# Issues with Housing

V0.3 - Prototype

# Controller board

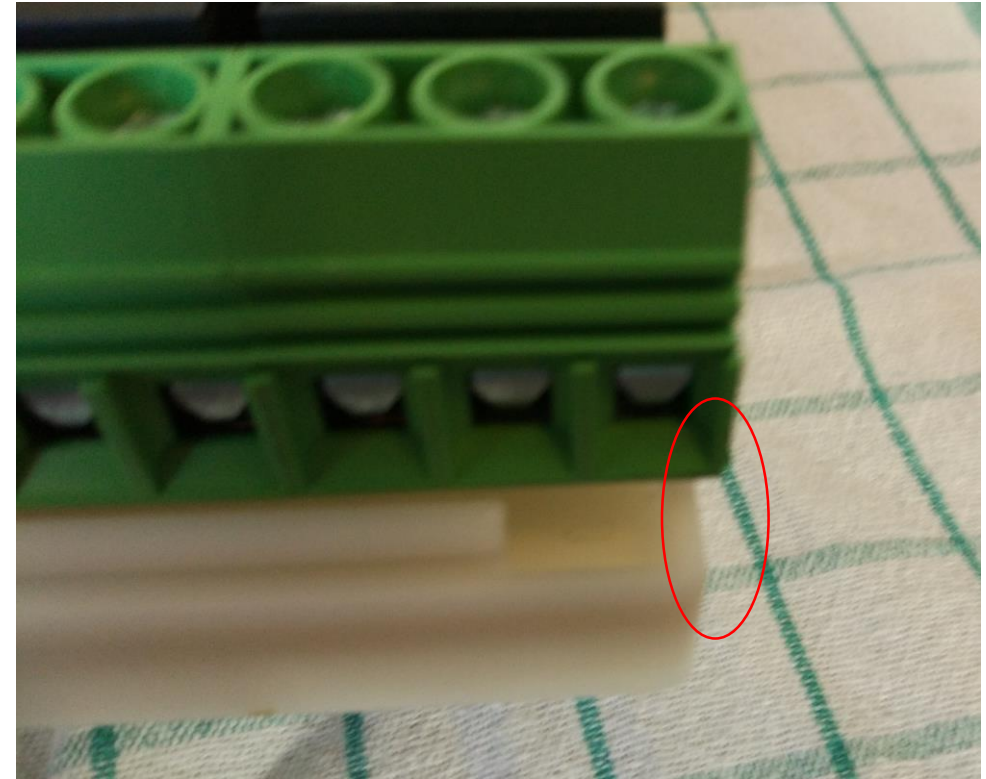
Controller board doesn't fit.  
Ethernet port not at edge of housing

# Relay Board

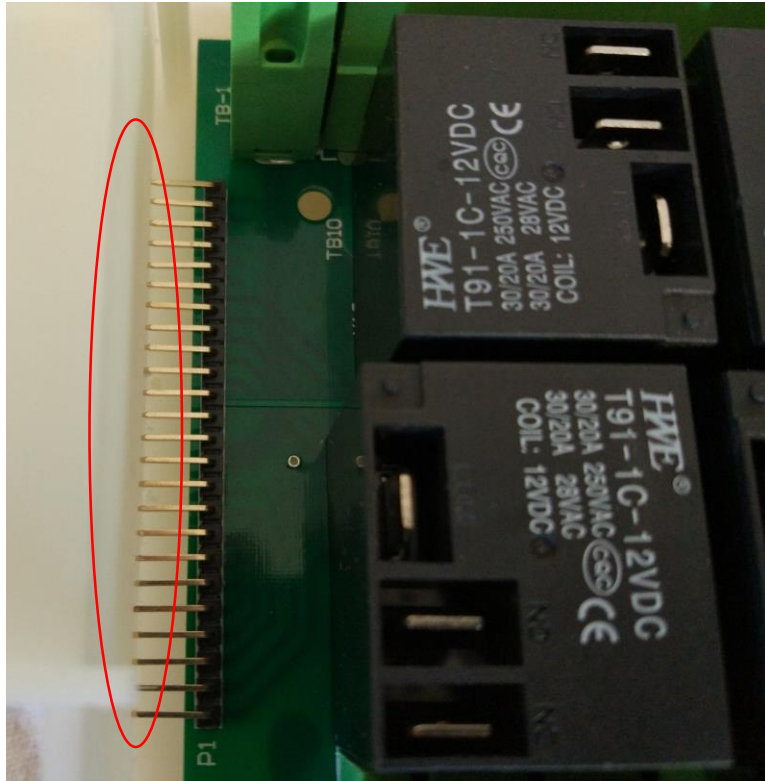
Board is longer than housing  
Mounting screws have no support in housing

# Transformer board

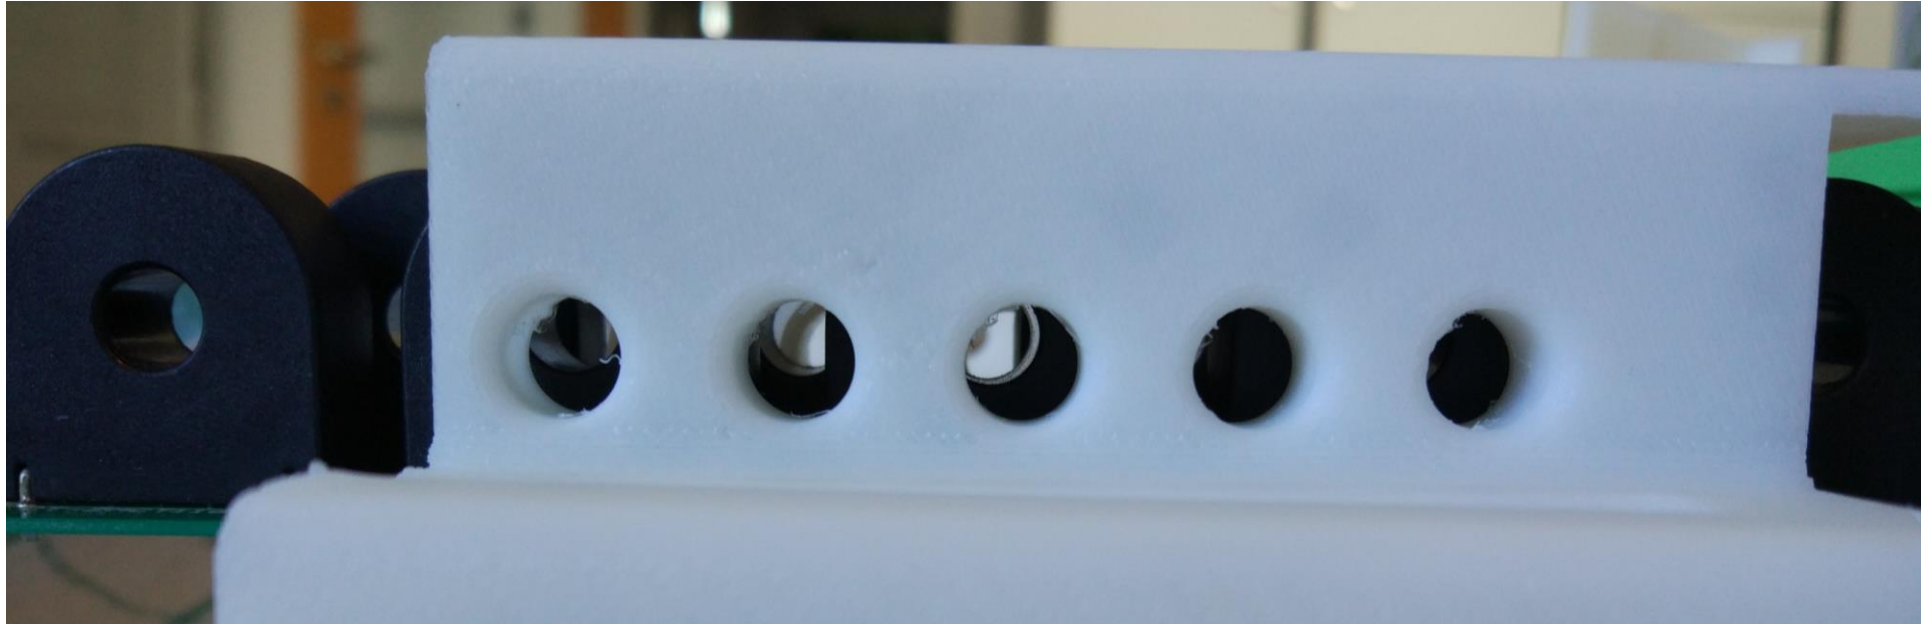
Holes do not align with transformers

Also board doesn't fit into guide (board too thick, plus consider solder on underside)

# Battery & Zigbee

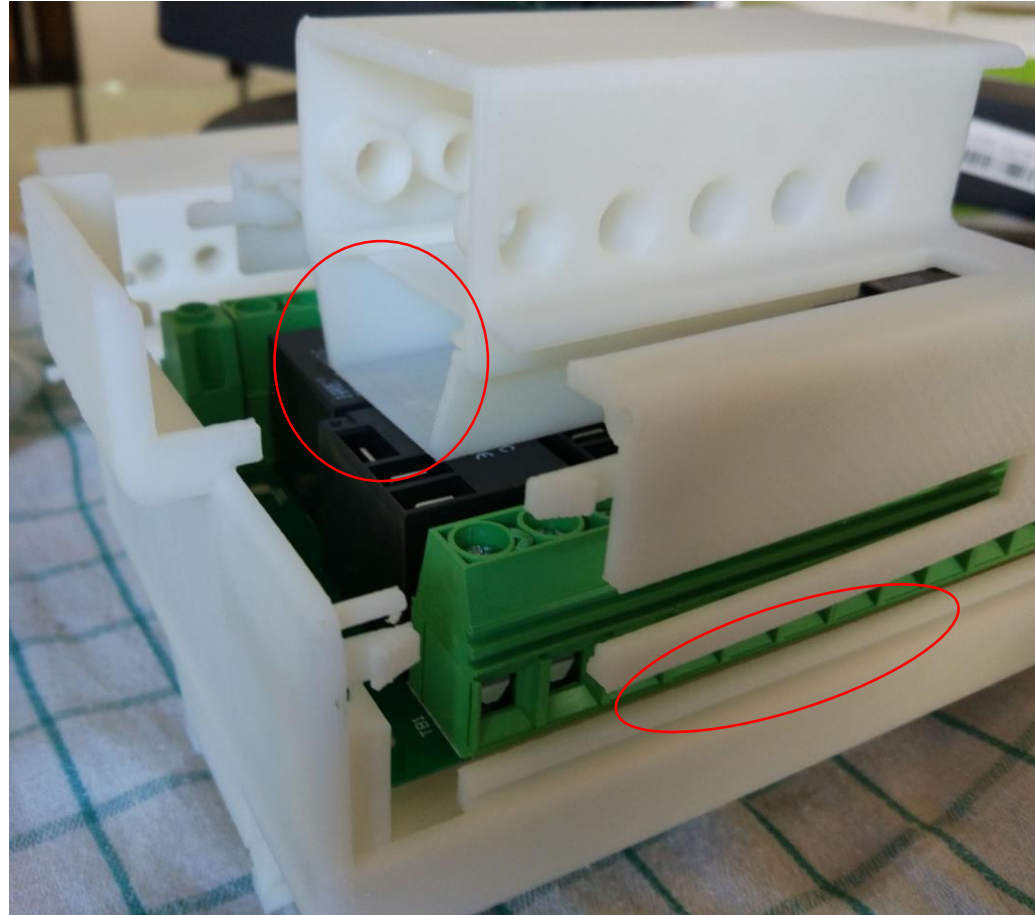
This doesn't fit
